PLANNING BOARD

To: Dover Planning Board
From: Courtney Starling, Land Use Director
Date: June 2, 2021
Subject: Site Plan Review to construct a pool and cabana in rear yard
Location: 210 Dedham Street

Site Photos

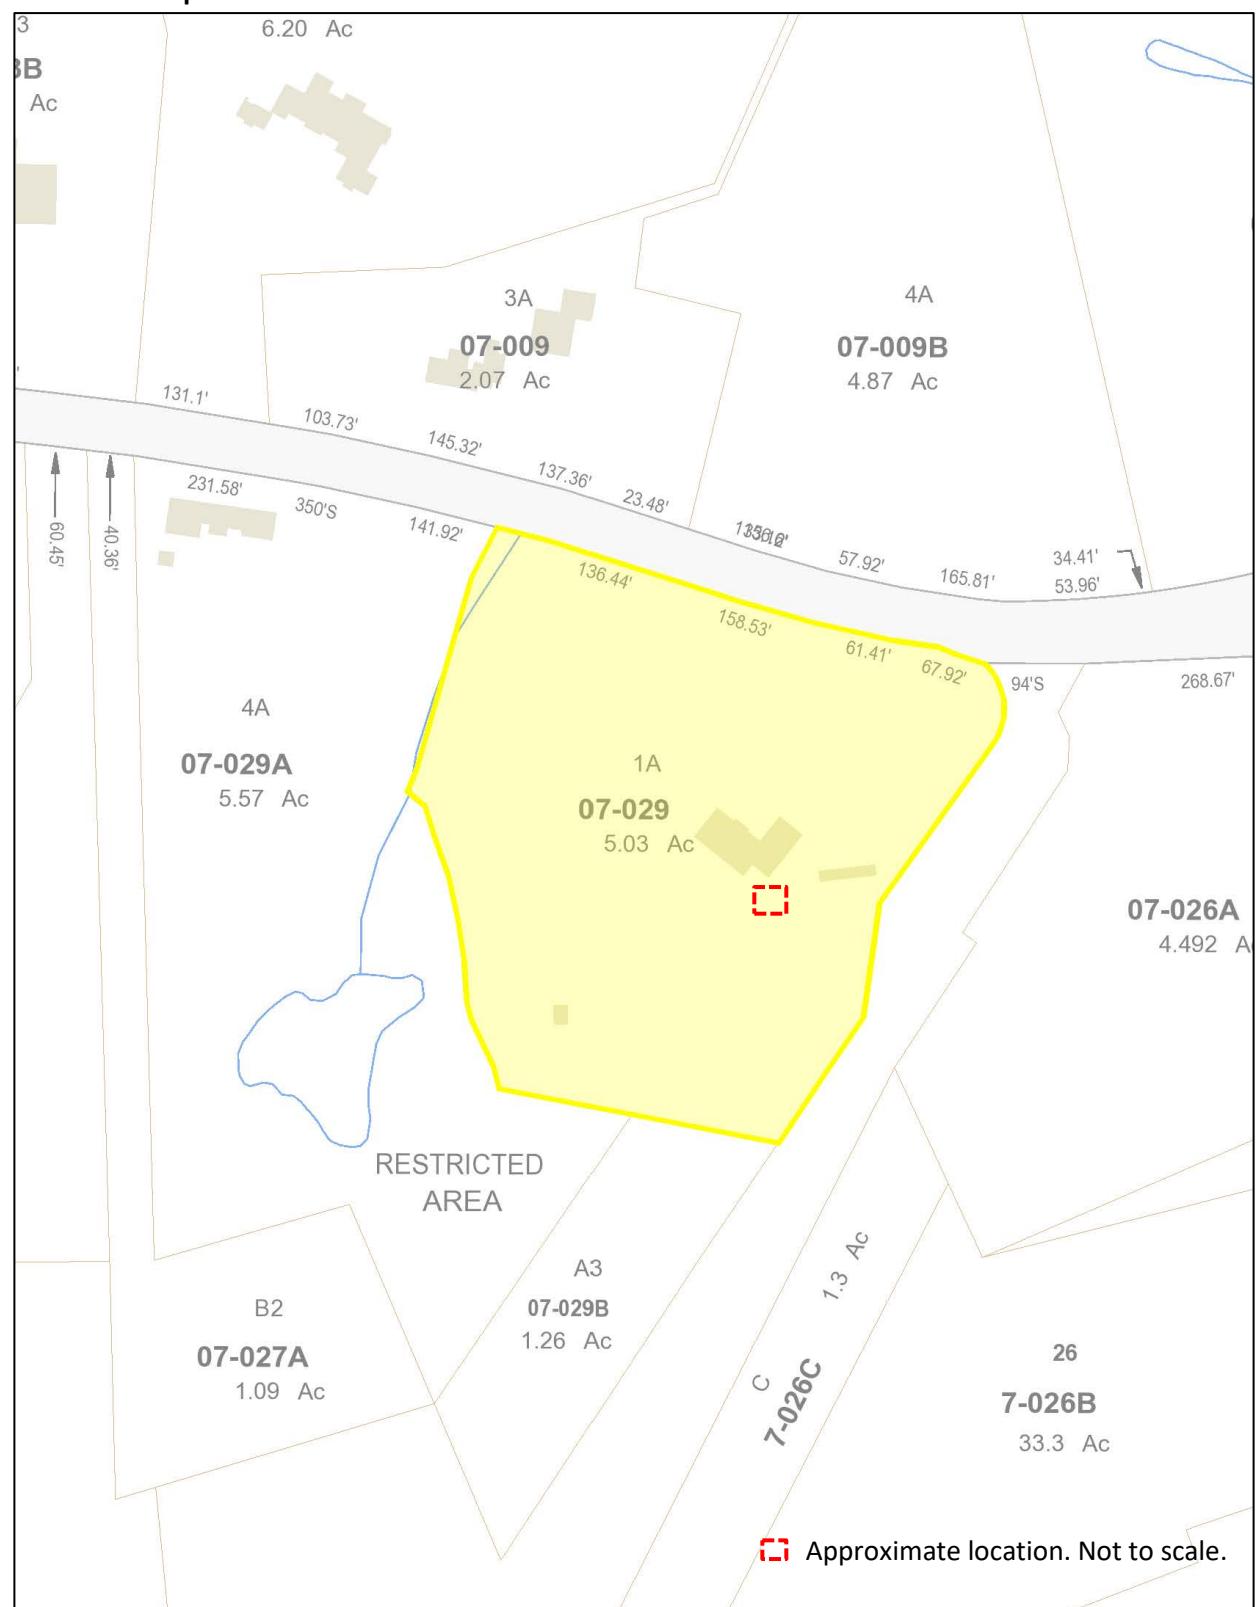
- d) The arrangement and appearance of proposed new buildings, structures, colors and materials, or changes to the aspects of a site;**
The existing structure is brick Georgian revival that was originally constructed in 1929 and is currently undergoing significant renovation; the proposed cabana does not seek to replicate the architecture of the existing structure, but complement it with a modern structure. From a historic preservation

perspective, it is generally preferred to complement the existing architecture rather than attempt to replicate it with modern materials. While the proposed cabana is a departure from the existing architecture, in terms of appearance and materials, it does not appear that this will be in any way detrimental to the existing property.

The proposed structure is positioned at the rear of the property and is well screened from neighboring properties by existing vegetation and the main house.
